Docket Item # 6
BAR CASE # 2008-0159

BAR Meeting
November 5, 2008

ISSUE: Addition/Alterations
APPLICANT: Karl and Lydia Svoboda
LOCATION: 113 Princess Street
ZONE: RM/Residential

Figure 4. Proposed front (south) elevation with projecting bay window and dormer.

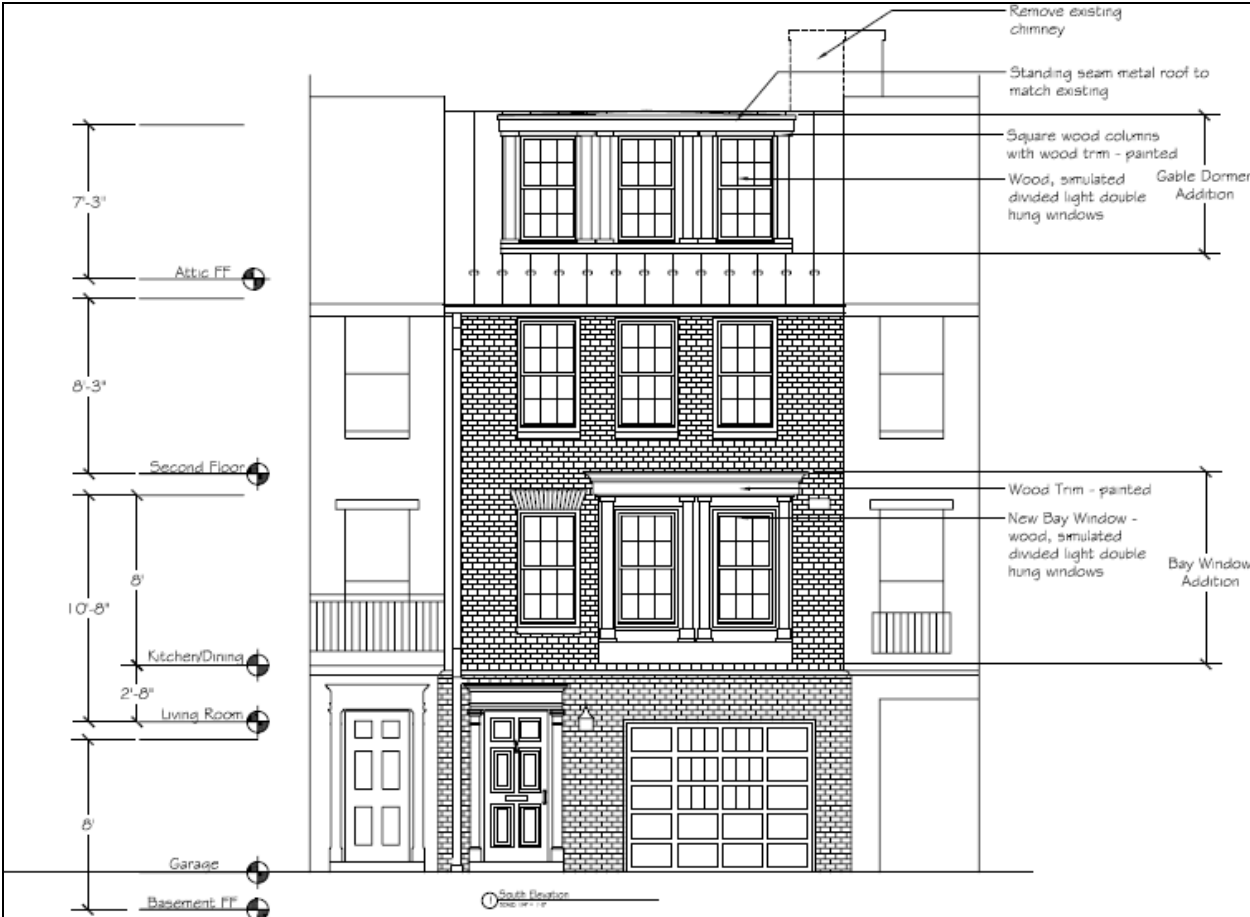
1. That the applicant refine the design of the front dormer to reduce the dormer's size with smaller windows and to work with Staff for final approval;

Staff initially expressed concern about the height and appearance of the proposed dormer on the front elevation as proposed in the first submission. In the previous report, Staff found a dormer to be acceptable at this location but recommended that the height of the dormer not exceed the existing roof ridge height. The height has been reduced through the elimination of the gable portion of the dormer and replacement with a flat roof. Staff finds that the most appropriate dormer for this location is one that maintains the established three-bay rhythm of the façade. Staff finds that this can be accomplished in a variety of dormer arrangements. Staff notes that the Board has discouraged the use of shed dormers on front elevations. The applicant here proposes a flat roofed dormer, which, although similar in form to a shed dormer, has a less prominent roof. Staff finds that the flat roofed dormer is acceptable in this location. Historically, a dormer has smaller windows than the rest of the façade, in order to provide light and ventilation to an attic story. Staff recommends that the applicant reduce the size of the windows in the proposed dormer, and thus the overall size of the dormer, to prevent the dormer from dominating this elevation. Staff recommends that the applicant work with Staff for final approval of a reduction in window size.

Figure 5. Proposed rear (north) elevation.

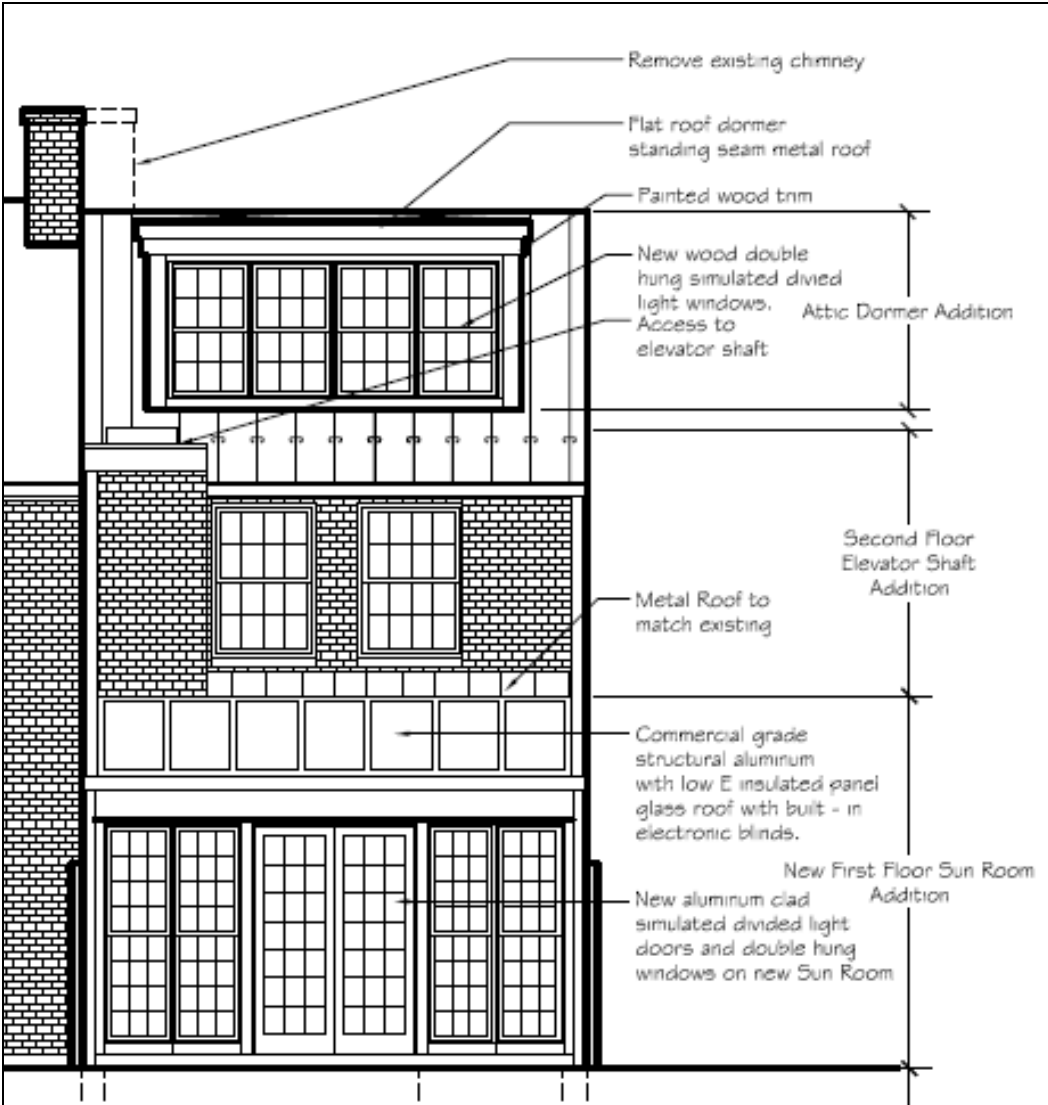
2. That the applicant further explore the opportunity to retain the chimney *in situ*;
3. That the applicant install nightshades on the rear addition to control light spillage;

The *Design Guidelines* state that “the design of an addition should respect the heritage of the historic building to which it is attached as well as adjacent buildings...or which echo the design elements of the existing structure.” Staff finds that the proposed one-story addition is compatible with the architectural style found of this townhouse and the surrounding area. While the proposed glass roof on the addition is not a traditional roof material in the historic district, Staff finds that it is acceptable in this circumstance as it will not be visible from the public right-of-way due to the 6’ fence raised above the alley level at the rear of the property. To mitigate light spillage from the glass roof, Staff recommends that nightshades be installed. A portion of the elevator shaft will be visible from the rear, but Staff finds that the choice of material, brick to match the existing, contributes to its compatibility.
